Service Bulletin

Bulletin No.: 10-03-08-001B

Subject: Front Suspension Noise Over Bumps in Cold Weather (Install Revised Front Stabilizer Shaft Insulators)

Models: 2010-2011 Cadillac SRX

2396869

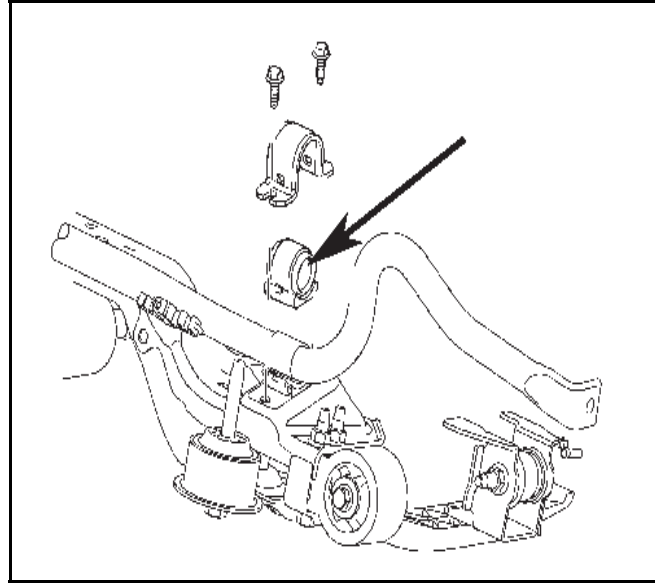
This condition may be caused by the interface between the front stabilizer shaft and the front stabilizer shaft insulators (bushings).

Remove the left and right front stabilizer insulators (bushings). Refer to Stabilizer Shaft Insulator Replacement in SI. Wipe off the surface of the stabilizer bar to remove any loose rubber or grease residue. Install the revised left and right stabilizer insulators (bushings). For installation instructions, refer to Stabilizer Shaft Insulator Replacement in SI. Install the new service stabilizer insulators (bushings) so that the chamfer edge is facing toward the outside of the vehicle. This will put the slits in the bushing facing opposite directions.
